# Illustrated Parts List - IPL Update

**CS2260/WH**

## 1. Carburetor

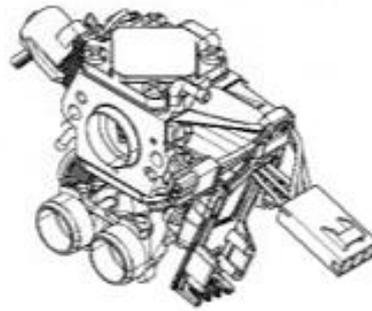
1. A new Inlet pipe, assy 583 96 41-03 has been introduced. The change has been made to ensure the assembly and to avoid leakage.
2. The New Carburetor, kit 501 46 33-05 consist of: New Carburetor ZAMA140058A, a separate support sleeve 582 02 51-01 and AT-instruction.
3. New article number and some minor changes on Air Nozzle due to change of supplier.
